Wiring the Clutch transformer 09UB100A16

When replacing the original 09U002EBR clutch transformer with the replacement 09UB100A16 there will need to be some changes in the wiring.

Wiring of 09UB100A16 clutch transformer

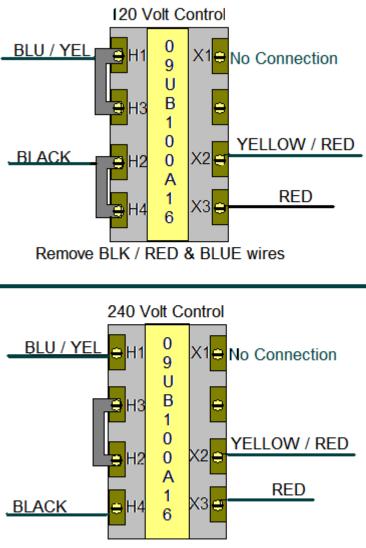
Remove BLK / RED & BLUE wires
